Central Zoo Authority

Sub:- Design for the construction of various enclosure at Nahargarh Biological Park, Jaipur.

The design for the construction of various enclosures at Nahargarh Biological Park, Jaipur was placed before the 45^{th} Meeting of the Expert Group on Zoo Designing of the Central Zoo Authority held on 30^{th} October, 2013. After detailed deliberation, the following observations were made:-

PROPOSED WORKING SECTION FOR HYENA ENCLOSURE

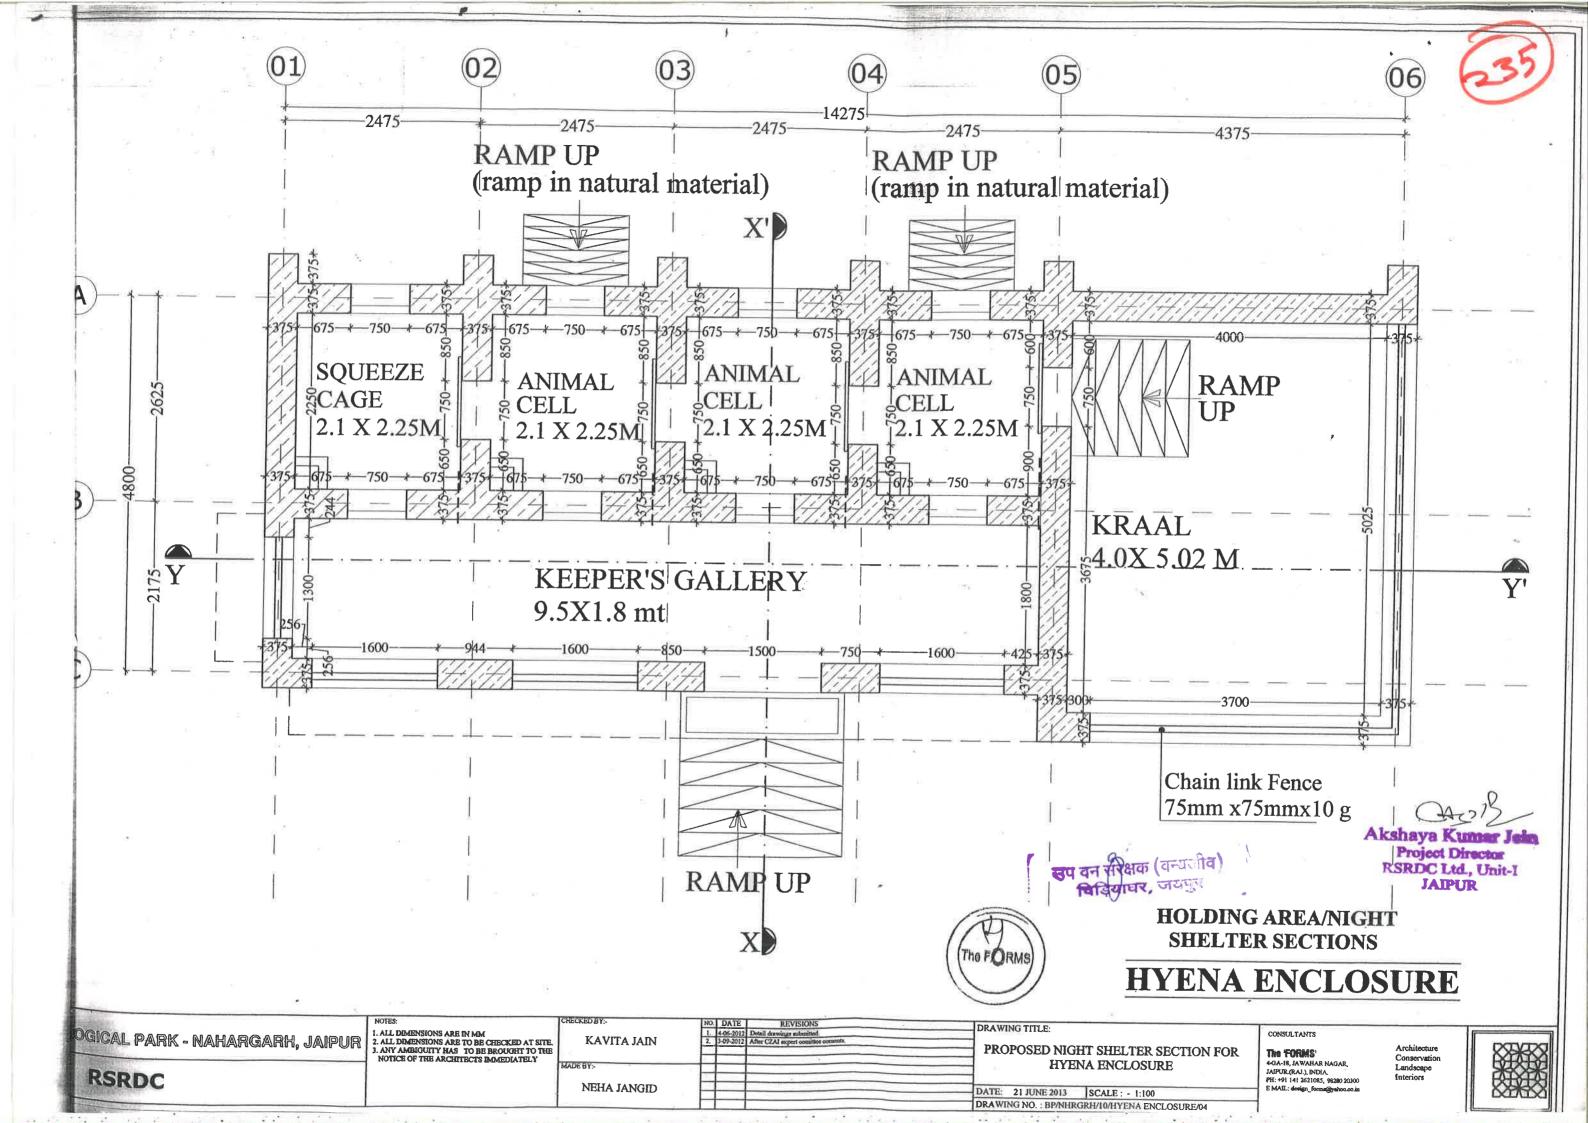
The design was approved subject to the amendments as indicated on the designs.
